City of Dallas

UDPRP Review Summary

PROJECT: Rivulet Development

Exhibit 1

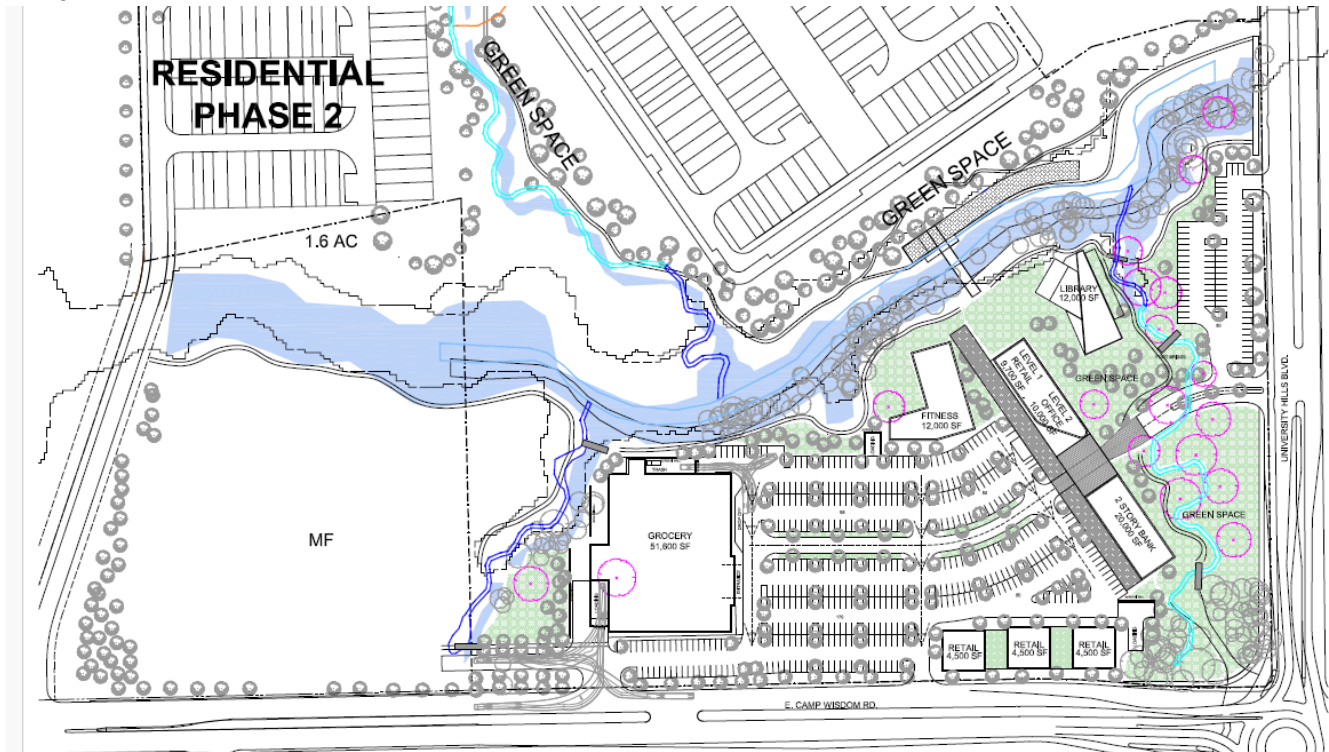
1. The Panel advises looking at how having buildings pulled closer to the street along University Hills / Camp Wisdom could enhance the development by making it more visible, inviting, and linking it better to the UNT campus.
 - a. Conversely, the Panel suggests looking at a greater commitment to placing buildings closer to the creek and conserving natural features closer to the street to take greater advantage of the land's natural features.

4. The Panel recommends maximizing the preservation of trees to conserve a feature that makes the site attractive today. The trees can help soften the new development activity by making the design feel "established" from day one.

(Applicant Response 10.16.23) Agreed with a greater commitment to the creek. Per Exhibit 1, our commercial plan has been revised to exclude the southwestern most corner of the site (labeled as "MF") as we do not yet have control of this property. Our plan is to maximize natural preservation along the creek and allow our story to be told along the creek corridor, as opposed to an urban story. This is particularly evident in the abundance of green space within the commercial development and open green spaces between and around buildings.

(City Response 10.23.23) With this revision and clarification as shown on Exhibit 1, you have met the Panel's recommendation placing development along the creek. Please note, as future detailed development proposals emerge, they will be documented and secured in single development incentive agreement or multiple development incentive agreements.

(Applicant Response 10.16.23) Agreed. A tree survey conducted by Pacheco Koch revealed that most of the significant trees are within the creek bed and at the corner of University Hills and Camp Wisdom Road. We plan to maintain the current natural landscape of the creek bed and creek banks, thus preserving most of the significant trees. Per Exhibit 1, significant trees within the commercial portion of the project are noted in pink/purple and only one would need to be removed under the current revised plan. Additionally, in advance of clearing the site, we will use iTree to identify removable Eastern Red Cedar trees below 8" to minimize total trees removed.

(City Response 10.23.23) With this clarification as shown on Exhibit 1, you have met the Panel's recommendation.
